RE: ADDITIONAL INFORMATION REQUESTED FOR THE MOORE RANCH IN  
SITU URANIUM RECOVERY PROJECT LICENSE APPLICATION (TAC  
JU011), SAFETY EVALUATION REPORT OPEN ISSUES.

**MOORE RANCH URANIUM  
PROJECT**

**SAFETY EVALUATION REPORT**

**OPEN ISSUES**

FIGURE 1.8-1 Moore Ranch Project Production, Restoration and Decommissioning Schedule

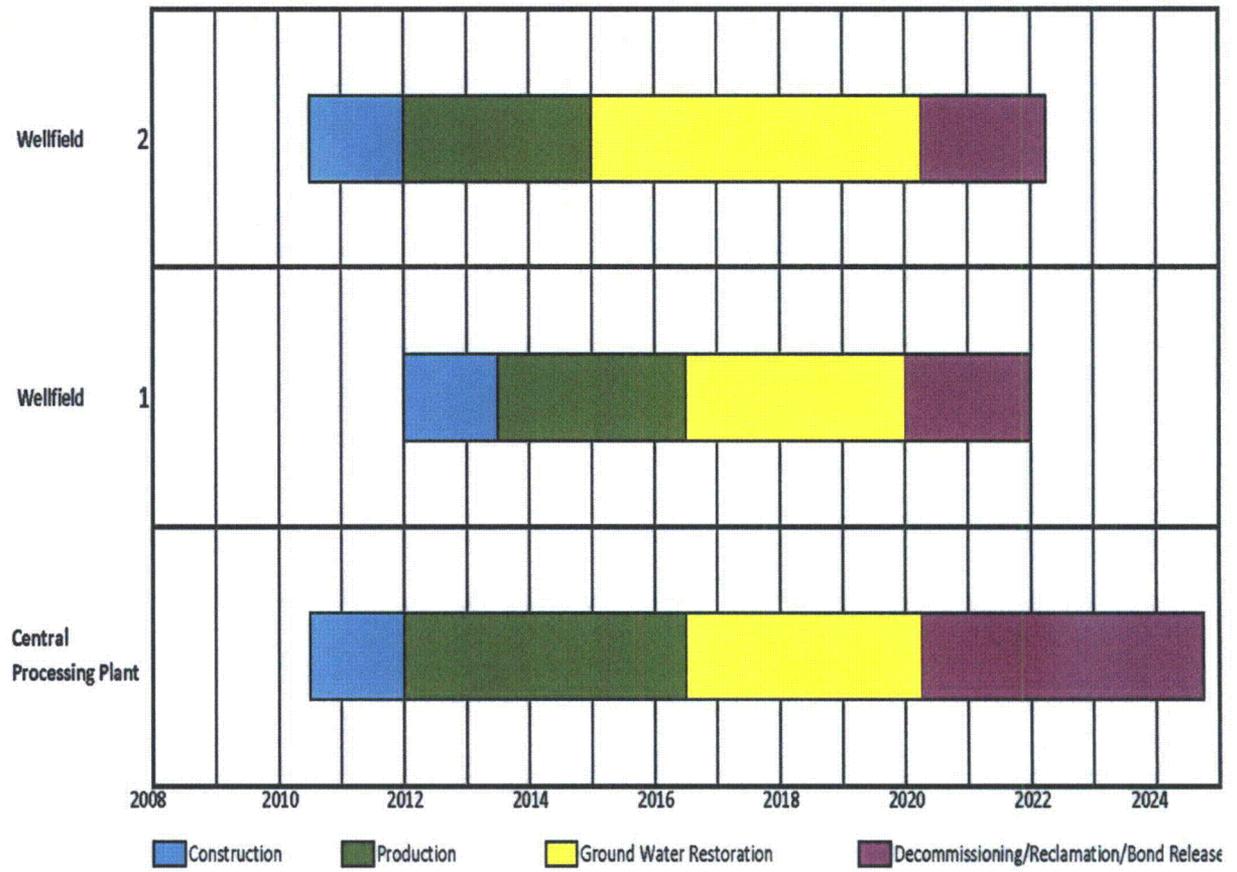
The schedule of activities shown in figure 1.8-1 of the TR indicates construction is to begin in early 2009 with production starting in mid 2009. This should be updated and consistent in the TR.

Figures 1.8-1, 3.1-6 and 6.1-1 have been revised to reflect the current schedule of activities and will be inserted in the revised Technical Report.

Figure 1.8-2 revised to reflect 2 wellfields as shown in Figure 1.8-1 Moore Ranch Production, Restoration and Decommissioning Schedule.

Figure Number:  
5.7-1

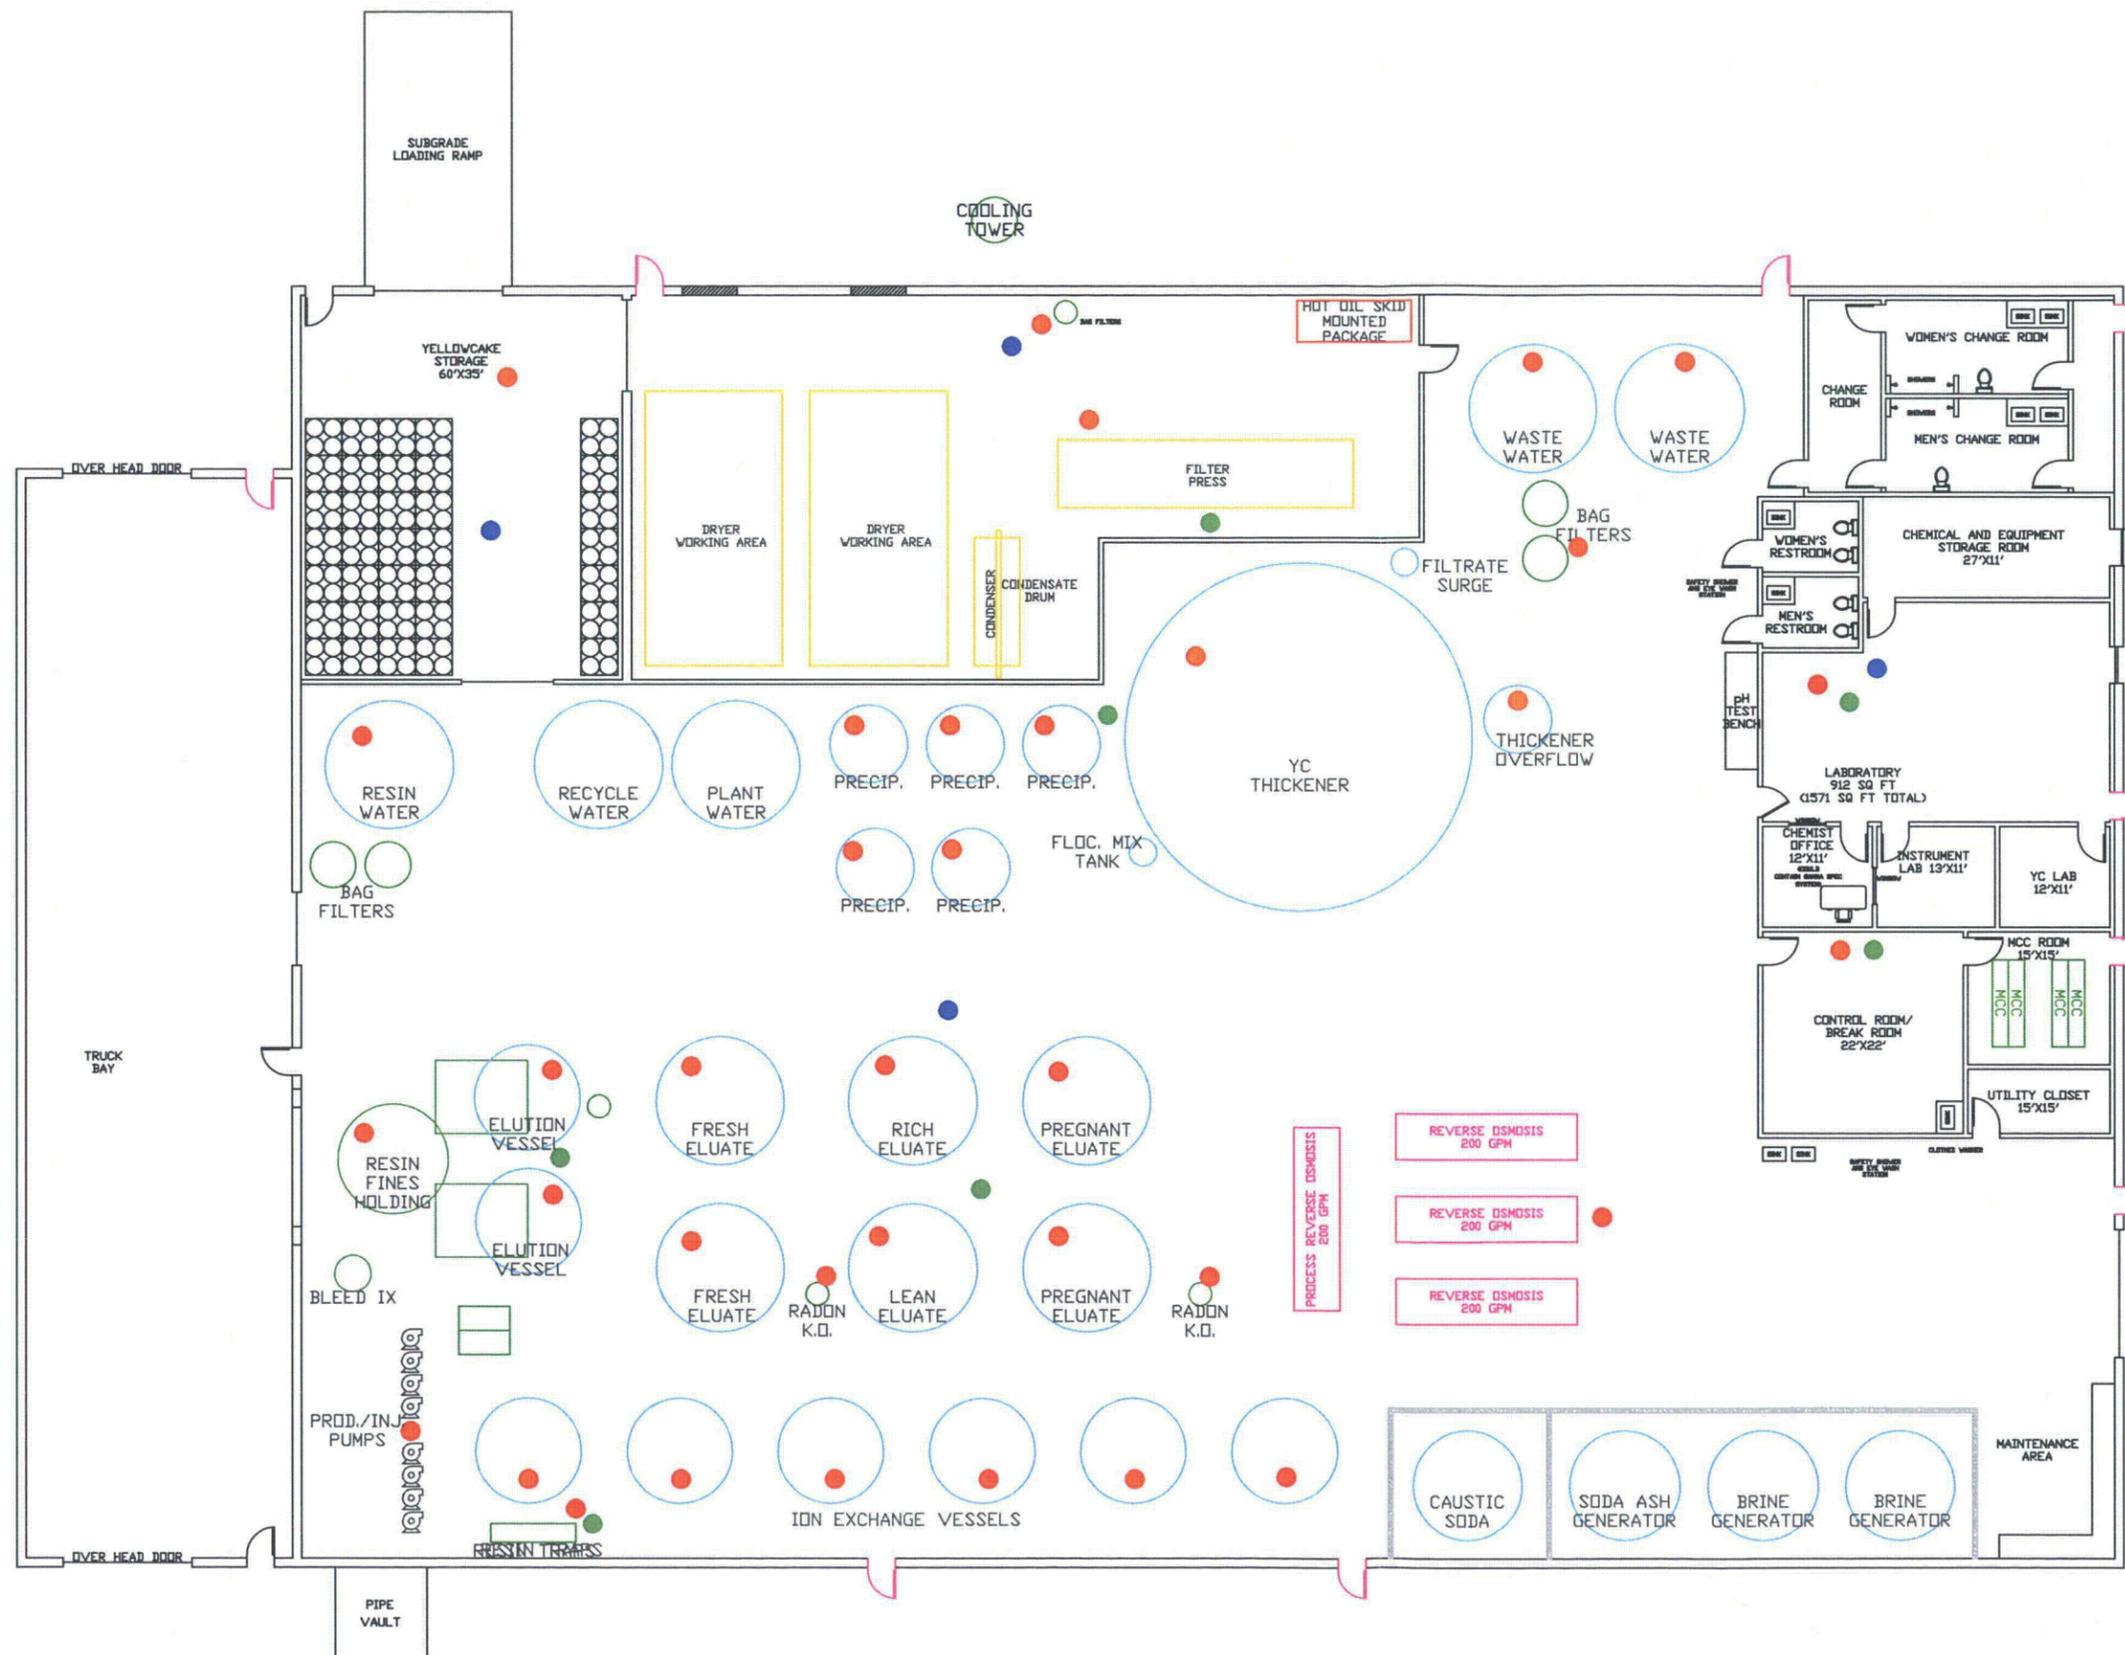
EMC indicated in Section 3.2.3.2 of the TR that a description of the areas in the proposed plant facility where radiological gases or air particulates could be generated is provided in Section 5.7 and shown on Figure 5.7-1 as monitoring locations. Note that Figure 5.7-1, intended to show monitoring locations for potential radiological gases or air particulates, is missing.

Revised Figure 5.7-1 has been provided.

**Figure 3.1-4 B**  
Location of Proposed Class I Wells

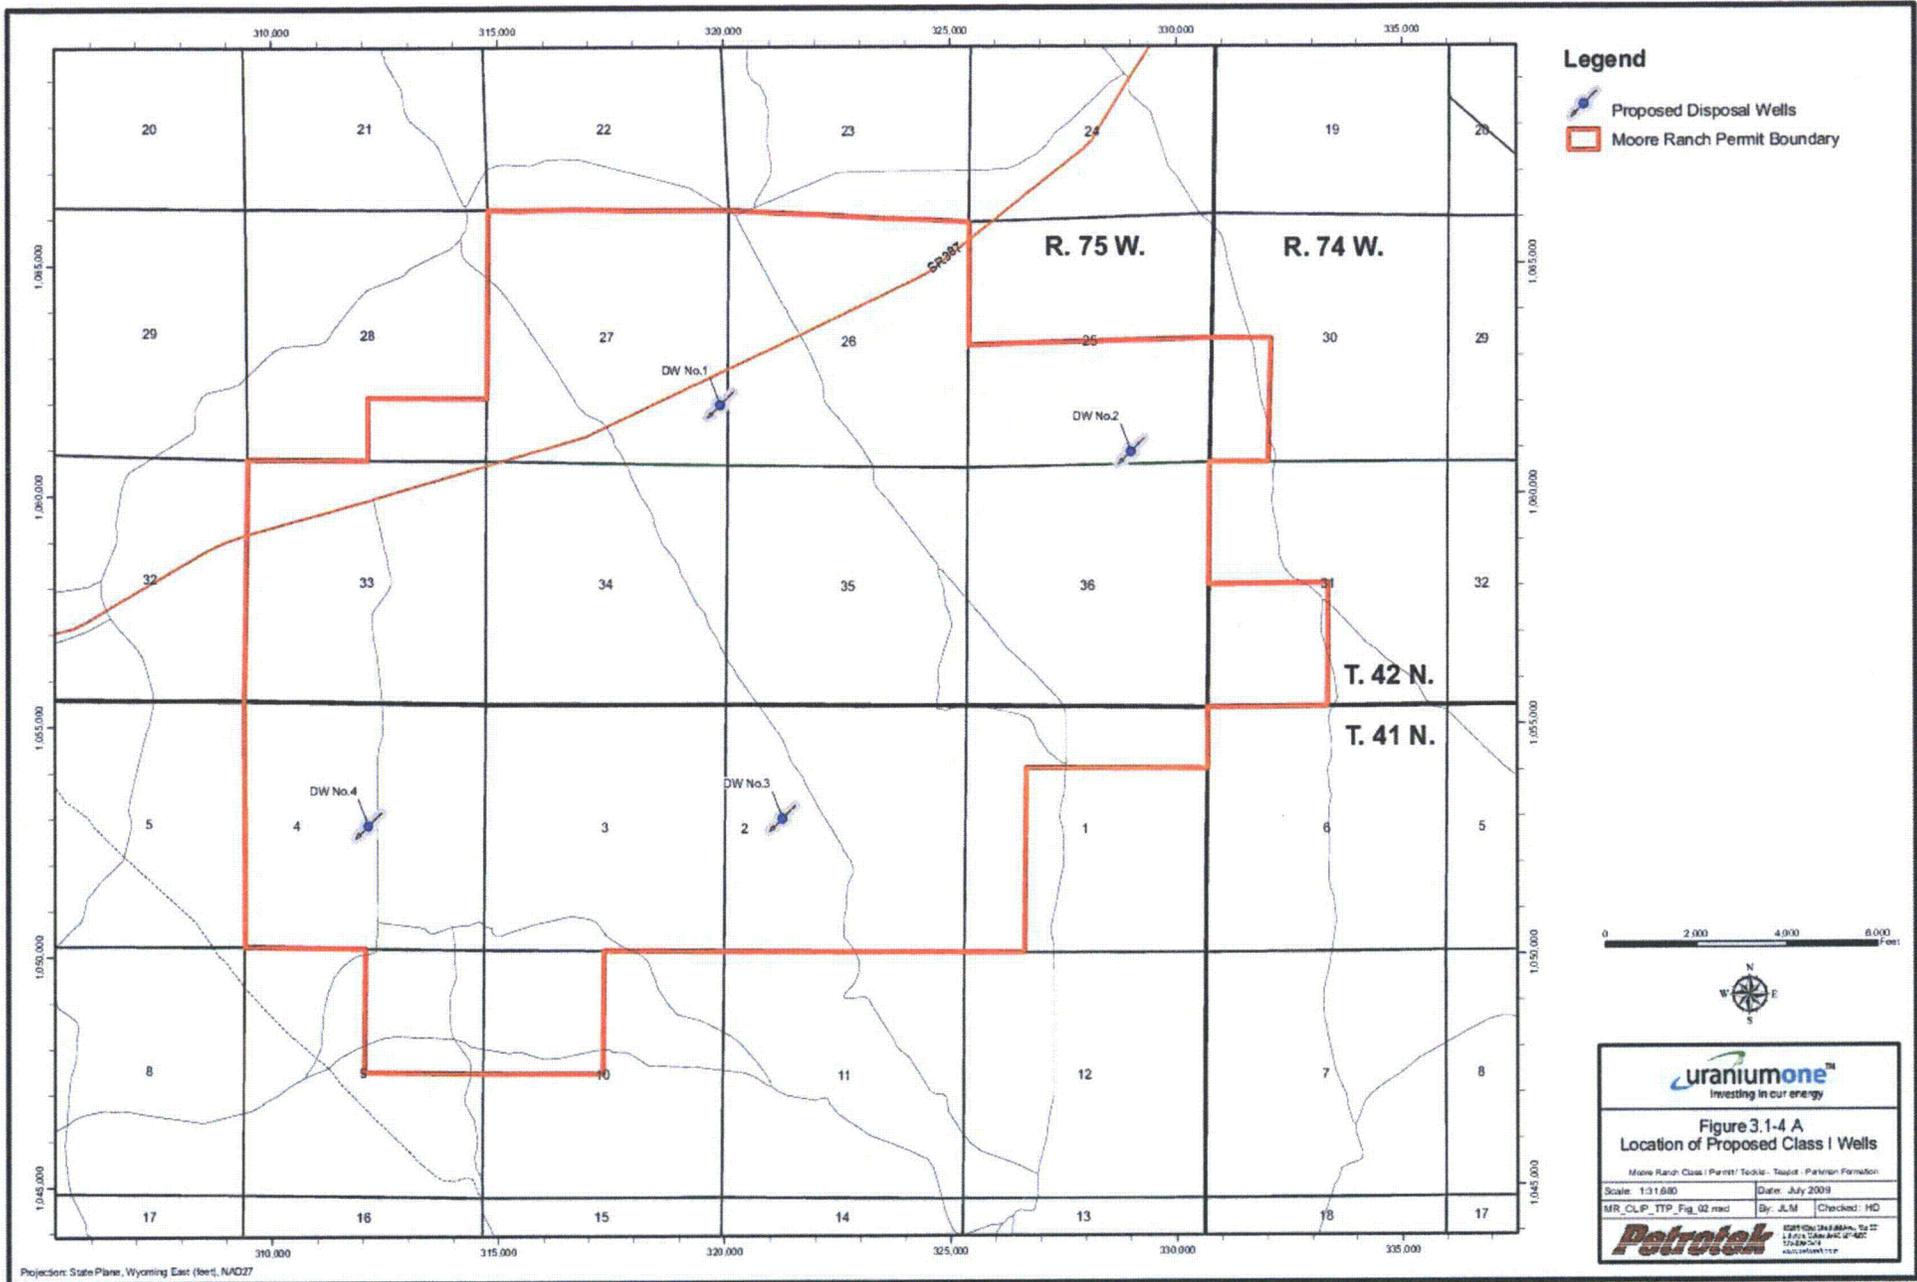
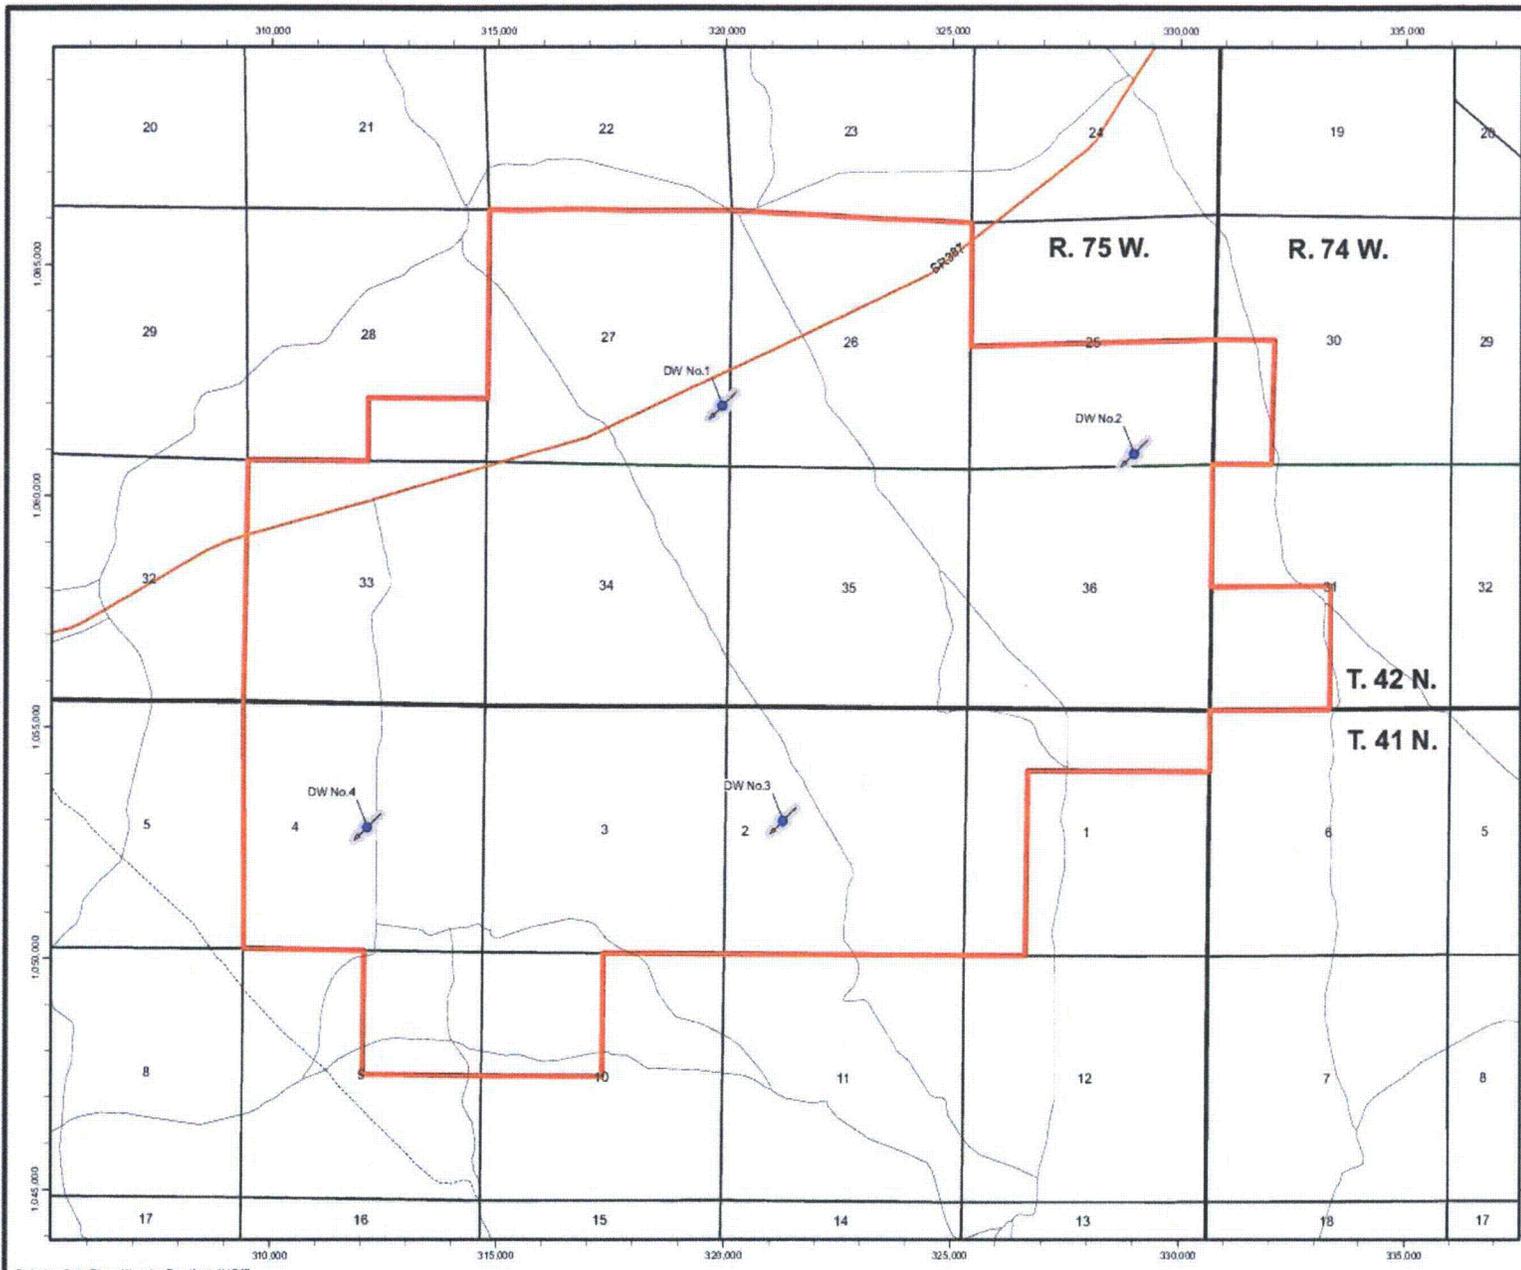
There are two minor issues related to the plans for liquid waste disposal: 1) TR page 4-6, section 4.2.2 incorrectly references Figure 3.1-5A when it should reference Figure 3.1-4A, and 2) page 4-8 has 2 paragraphs at the top that are duplicates of paragraphs on the previous page.

Figure 6.1-1

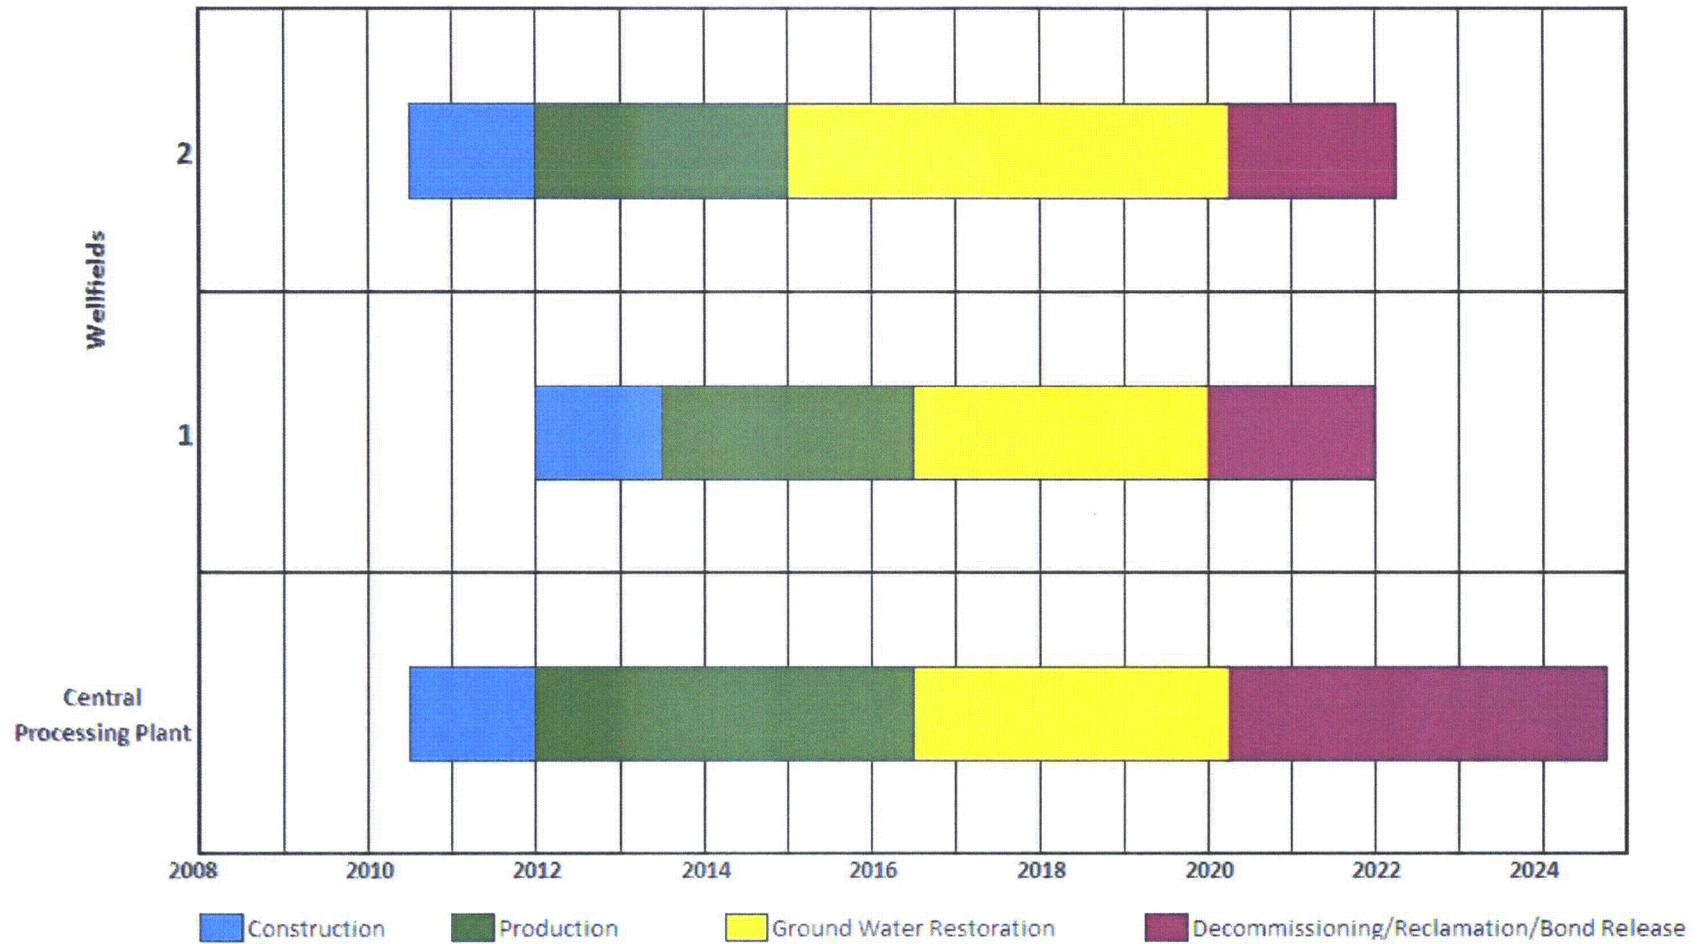
A preliminary wellfield restoration schedule was provided in Figure 6.1-1 of the Technical Report. EMC reported that based on the results of the numerical groundwater flow modeling, it will take approximately four years to restore Wellfield 1 and six years to restore Wellfield 2. This restoration schedule conflicts with Figure 1.8-1 of the Technical Report.

Figure 6.1-1 has been revised and is consistent with Figures 1.8-1 and 3.1-6.

Text in Section 6.1.4 Restoration Schedule revised to reflect updated Figure 6.1-1
